Re: Rockaway Quarry Site Reclamation Plan – File No. 2016-001
Supplemental Information in Support of June 28, 2004 Letter Outlining Approach
to Reduce Imported Fill to Reclaim Rockaway Quarry

ROCKAWAY QUARRY
 RECLAMATION PLAN
 PACIFICA CA

PRELIMINARY
 CONCEPT
 PLAN
 ILLUSTRATING
 REDUCED FILL
 OF THE
 DEVELOPMENT
 AREA SHOWN
 ON THE
 GENERAL PLAN
 FIGURE 4-7
 WITH AERIAL
 PHOTO
 ANNOTATIONS

Re: Rockaway Quarry Reclamation Plan, Response to July 30,
2024, CCC email to Stephanie Cervantes, City of Pacifica

DATE: 8/7/2024
 SHEET
EXH A.1

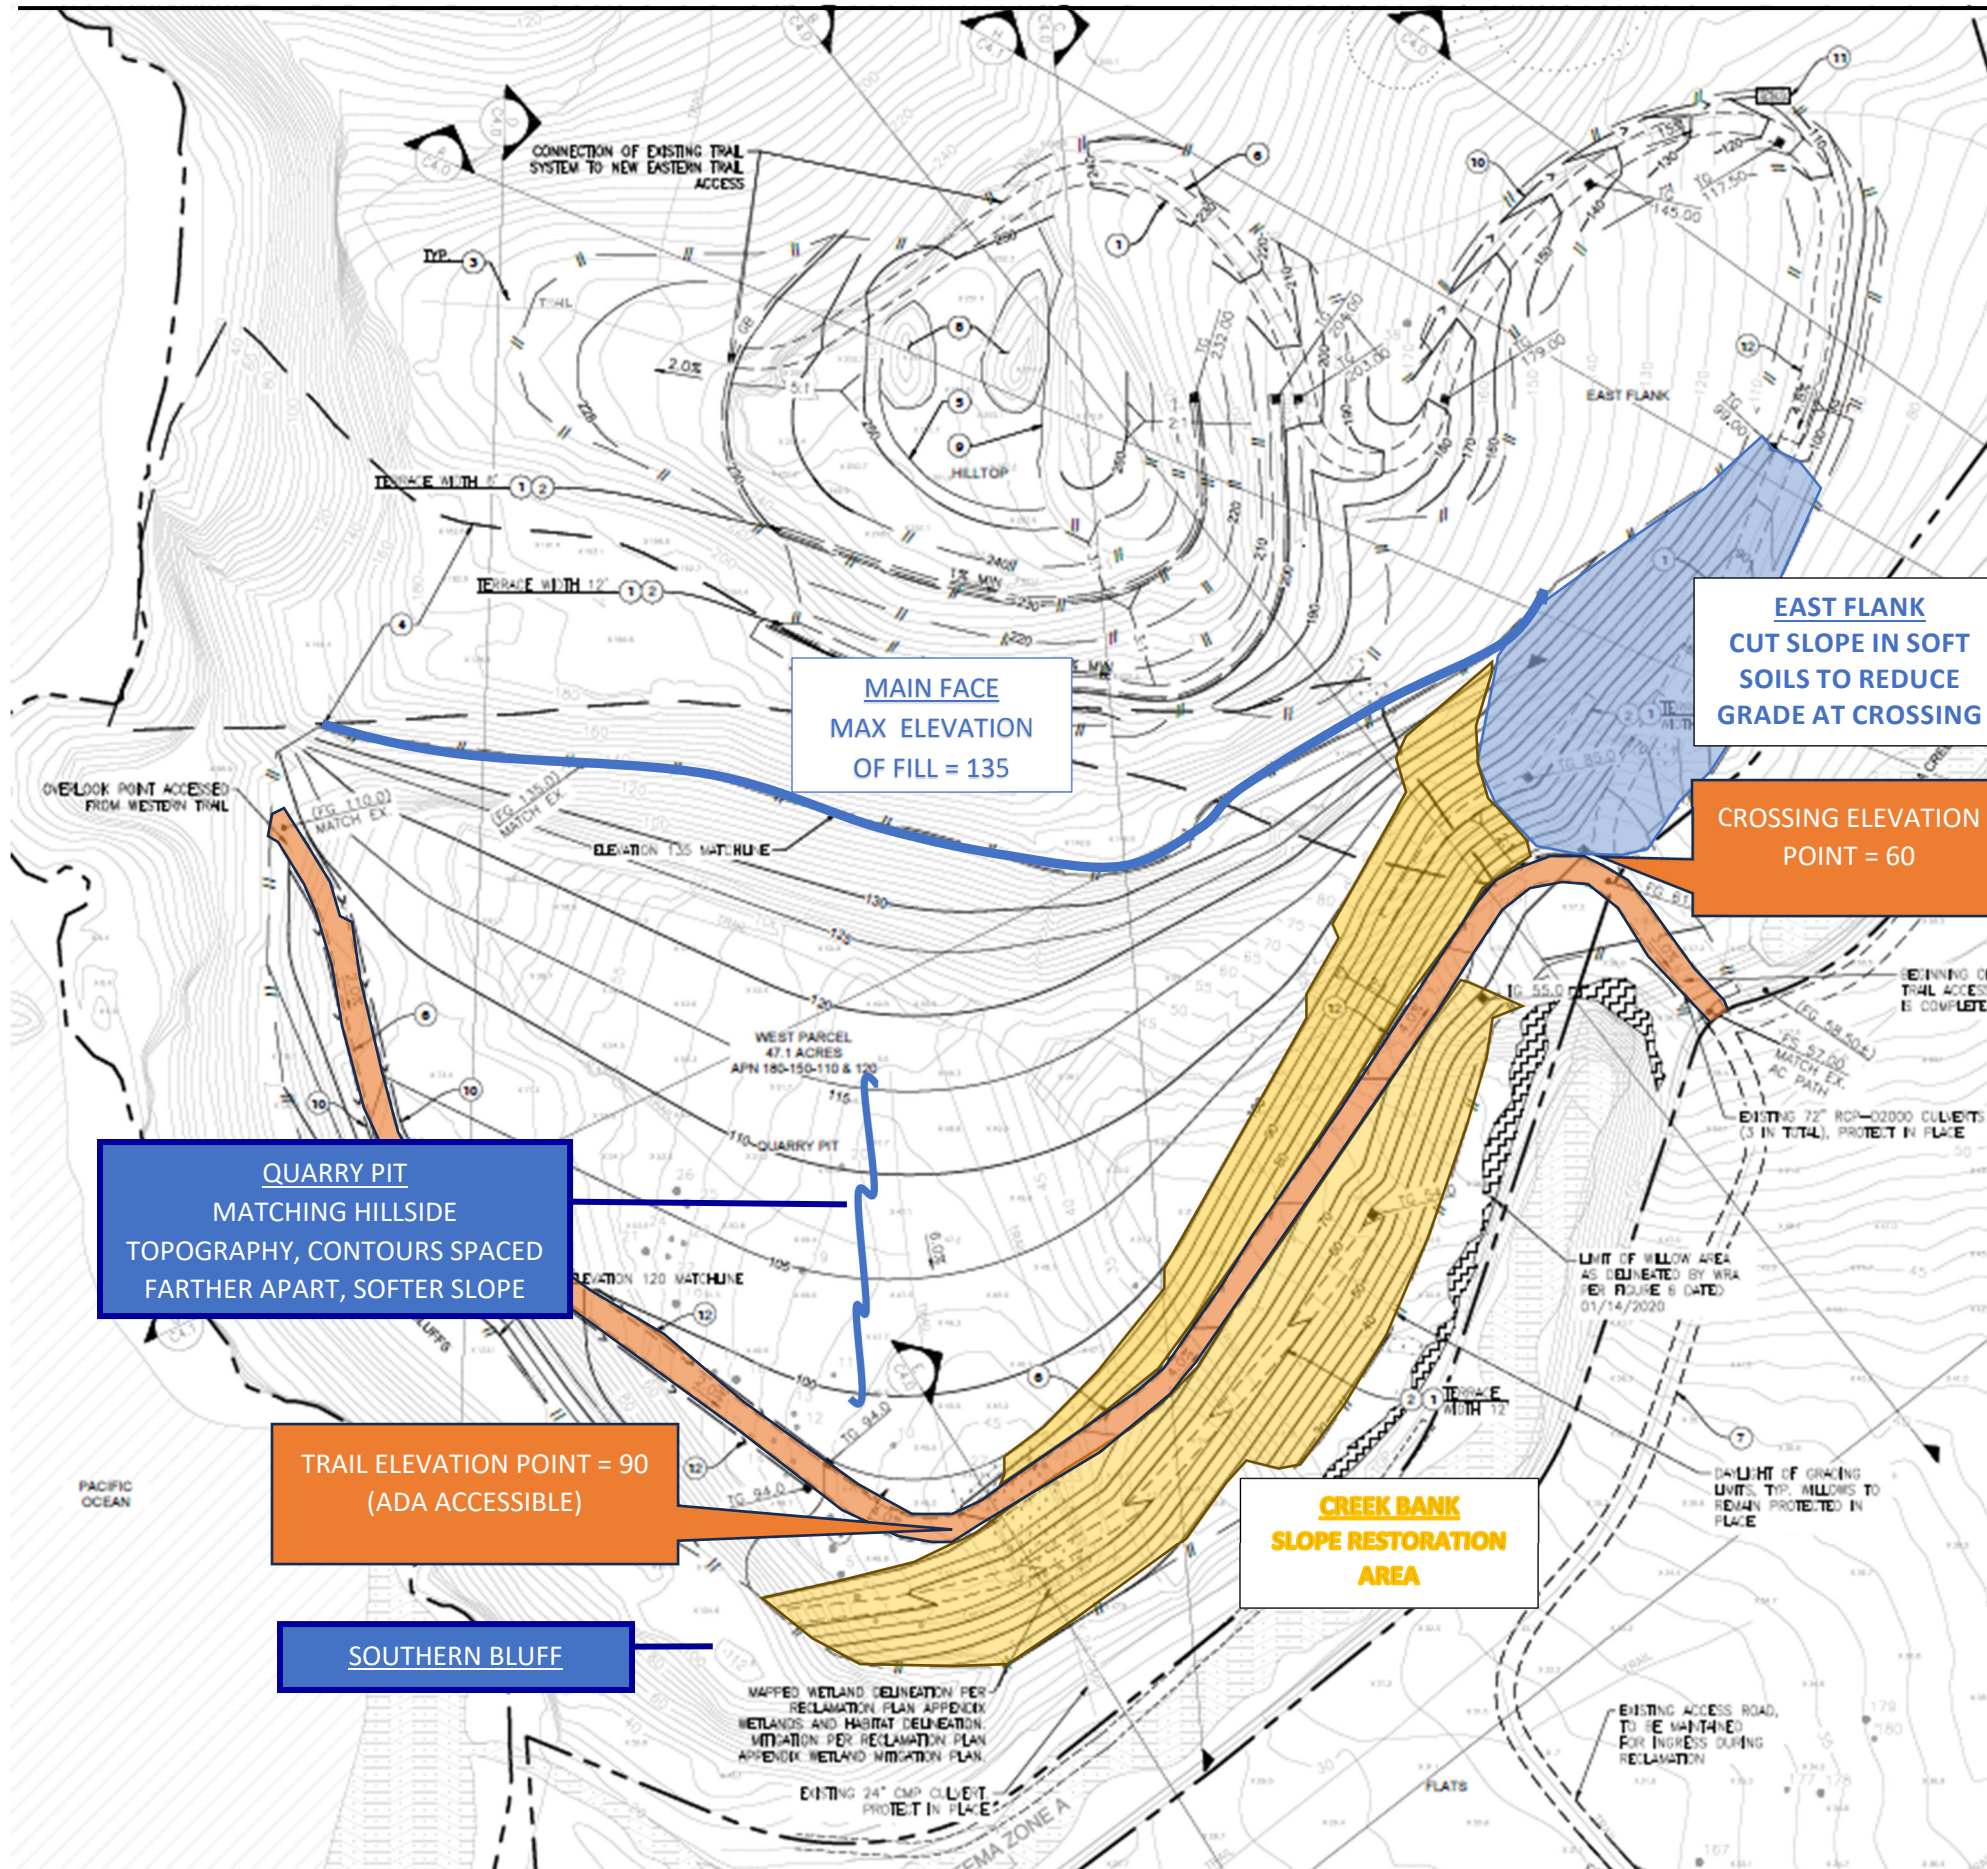
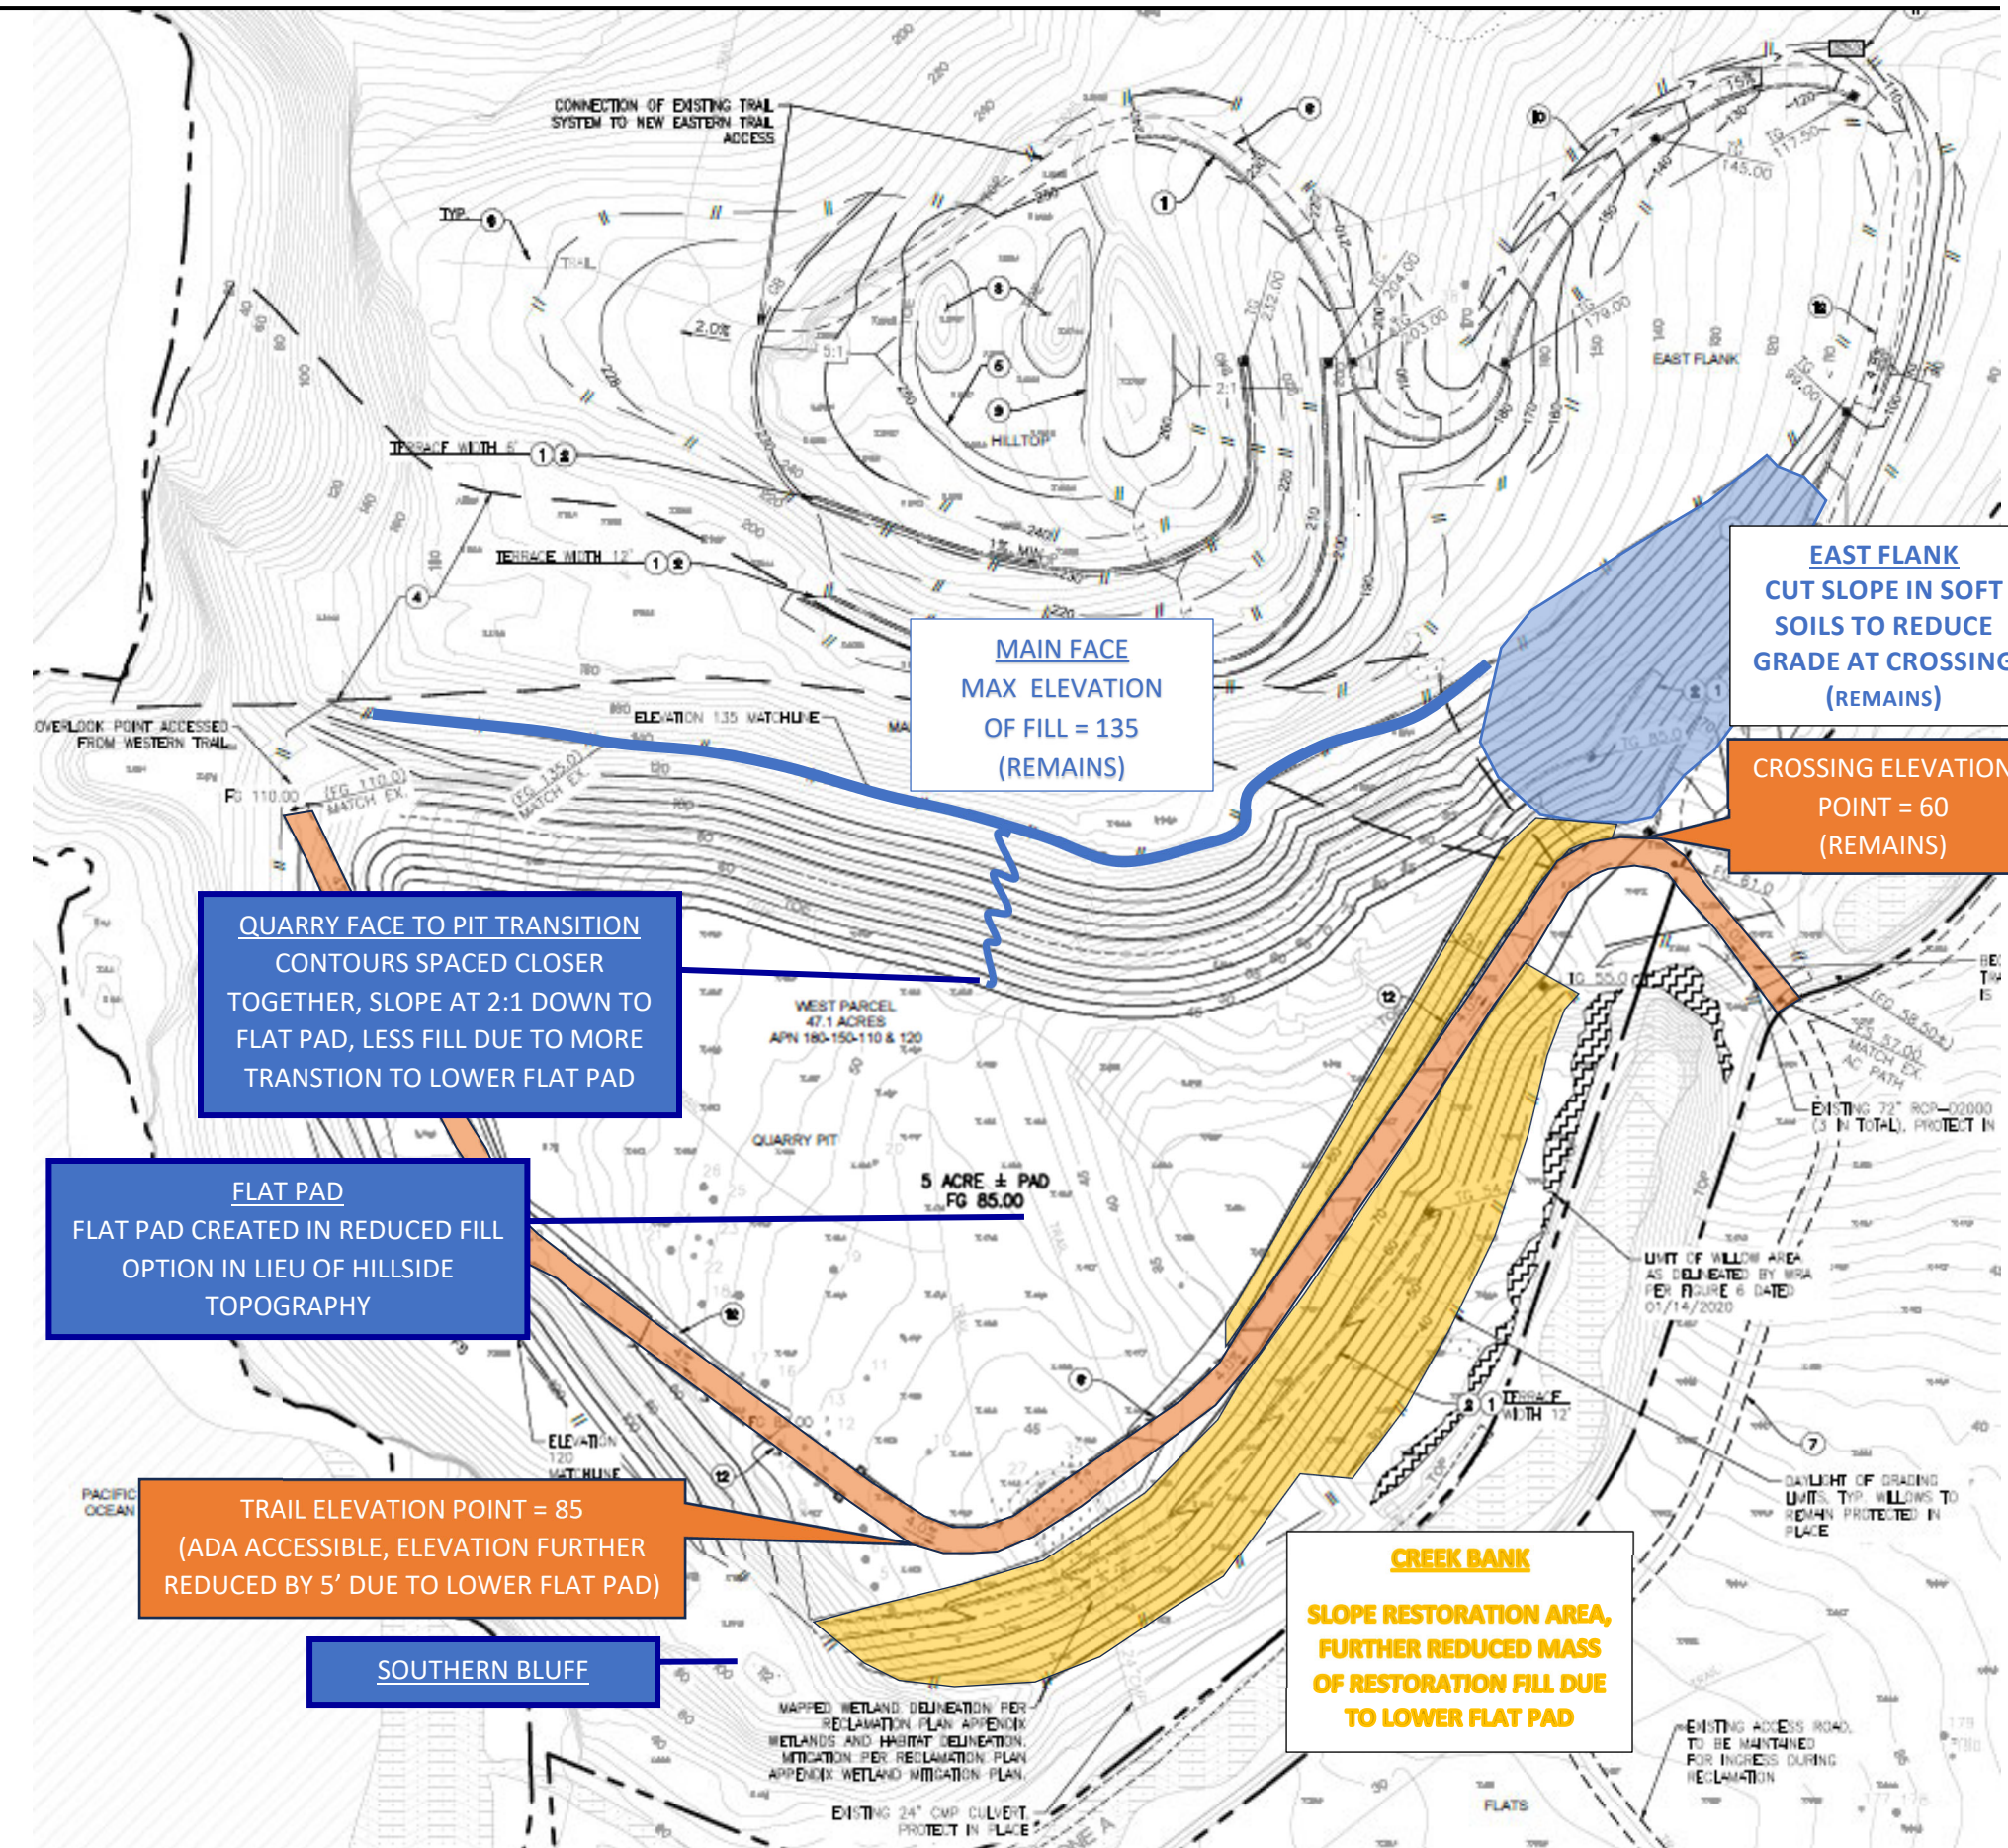
1) Explain if and how the Reduced Fill Alternative would change the grading ratios;

2) Clarify how much less fill would be placed in the quarry pit in the Reduced Fill Alternative;

3) Explain how the Reduced Fill Alternative would impact the existing wetlands and the proposed plan for wetland mitigation; and if reduced fill would lessen impacts to the existing wetlands;

4) Analyze how the Reduced Fill Alternative would differ visually from the proposed preferred project and provide new visual simulations;

7) Please clarify why a proposal for future development on the site would require less fill than if the Quarry remained open space.

a) The July 2, 2024, reduced fill alternative contemplates 583,000 cy of imported fill. This is a 45% reduction of imported fill. In addition, 67,000 cy of material would be cut and moved on-site to complete reclamation under this alternative. This results in a total amount of fill in the pit of 653,000 cy. The proposed 67,000 cy of cut is the maximum amount of fill able to be 'harvested' onsite without requiring blasting rock and installing a rock crushing facility to generate material that is geotechnically suitable for the final reclamation.

a) The original Reclamation Plan proposed 1,055,000 cy of fill in the quarry pit to return the landform to near pre-mining conditions. The total amount of fill placed in the quarry pit in this reduced fill alternative is 653,000 cy, a 38% reduction of fill. Of the 653,000 cy of fill, 580,000 cy is imported fill (the remaining 67,000 cy is cut and balanced onsite). The reduced fill alternative reduces the amount of imported fill by 45%.

a) The reduced fill alternative does result in impacts to the low-quality, man-made wetlands and sediment basin in the quarry pit. However, due to the reduced amount of fill, the amount of wetlands impacted are likely to be able to be reduced. In particular, the fill footprint can be pulled back and away from the creek and associated willows. We believe that impacts to a seasonal wetland in that area avoided. The exact amount of reduced impact can be calculated once this alternative has been refined after further vetting by the approving agencies. Any remaining wetland impacts will be mitigated at a 4:1 ratio as previously proposed and in the same location as previously proposed.

a) The reduced fill alternative visually looks relatively similar to the original proposal, but there will be a slightly reduced footprint and a 5-acre relatively flat pad at elevation 85. There will be a 2:1 slope rising from the flat pad up to elevation 135 where it will meet with a stable portion of the existing quarry face. Additional fill will be placed above that face at roughly the 180 elevation contour and extend up to the hilltop (elevation 260) in a 2:1 slope on the east, but a more gradual 3:1 and 5:1 slope in the south and west, respectively.

- a) While the original Reclamation Plan proposal had a designated SMARA end use of Open Space, it also left the site in a manner that was usable for a variety of future uses. This configuration also aligned with the City's General Plan designation which allowed for 7.8 acres of Visitor Serving Commercial use on the West Parcel. The July 2, 2024, reduced fill alternative reduces the size of the pad that may be used for future uses on the West Parcel to 5 acres. The difference is less about end use designation and more about the amount of space usable for a variety of subsequent uses following reclamation.
